Subject: **Supplemental Information; Preliminary Approval of US 19 Secondary Access for proposed Anclote Harbor Apartments**

Re: Anclote Harbor
FDOT Review of Second Access

Subject: **Anclote Harbor – US 19 Access Exhibit/Guardrail Analysis**

TYPICAL SECTION
US 19
STA. 116+00.00 TO STA. 116+75.00

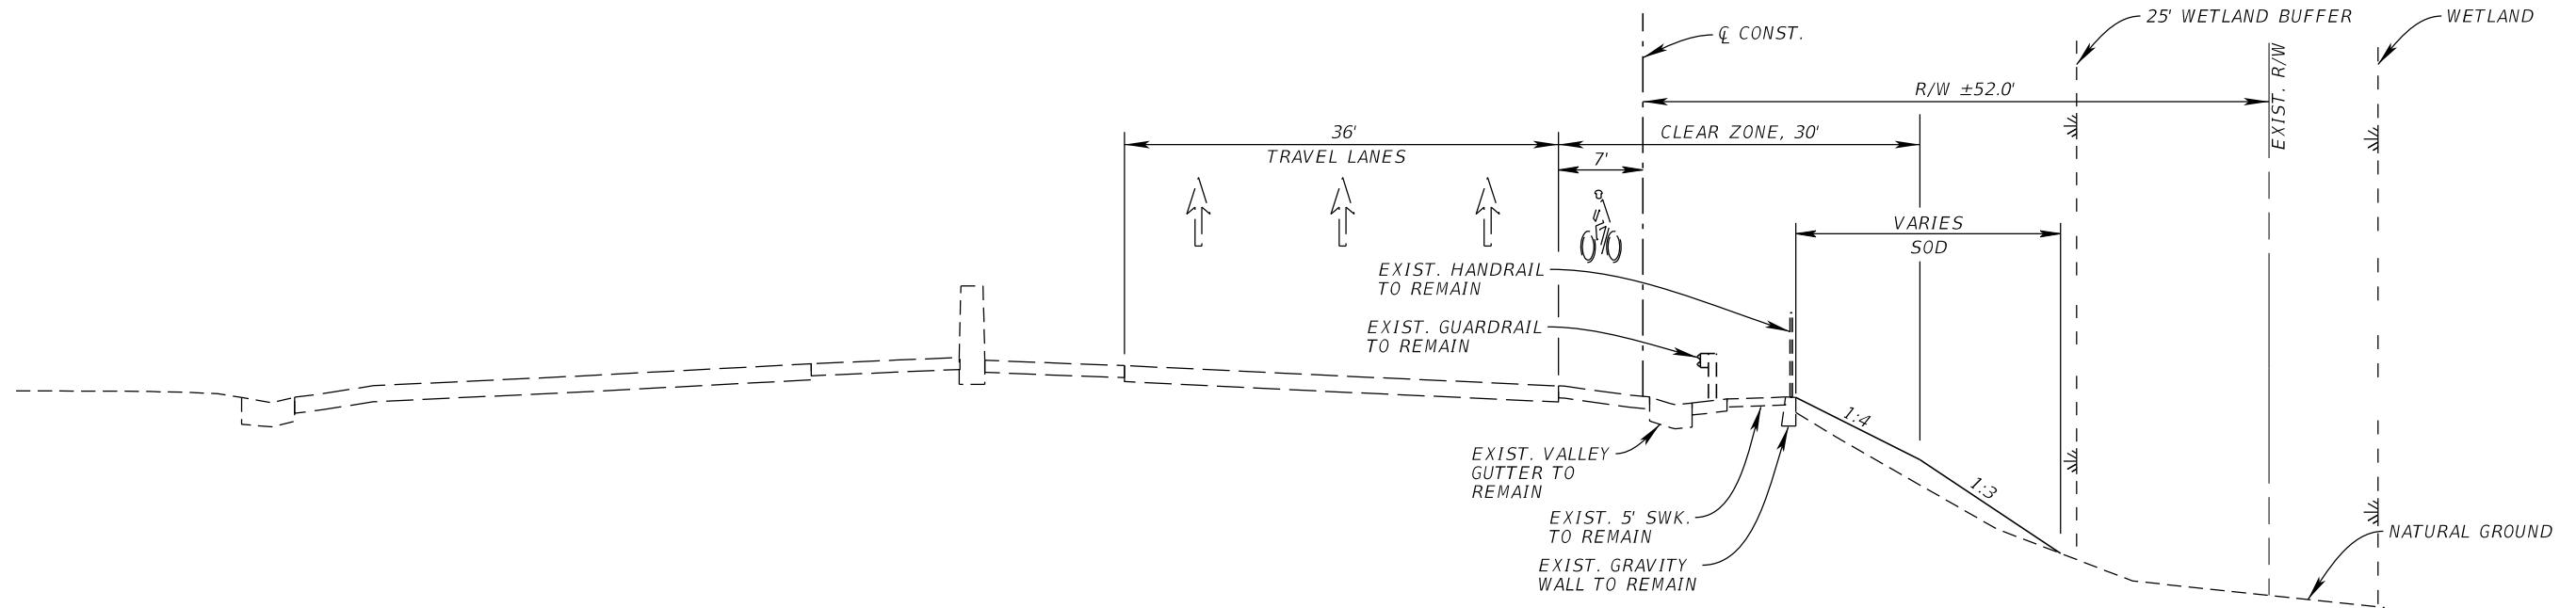
Make sure you provide a cross section generally center of the right turn lane (not the entire right turn just the driveway) across the driveway, sidewalk and how it ties to the existing ground. Include a 2-level area behind the sidewalk. The tie in should be 1:3, but 1:4 would be better. You are already impacting the wetland and the additional fill will not be that much.

NOTE:
1:4 MAX SLOPE USED BEHIND
GUARDRAIL WITHIN THE CLEAR
ZONE AS THESE STATIONS FALL
WITHIN THE GUARDRAIL LENGTH
OF NEED.
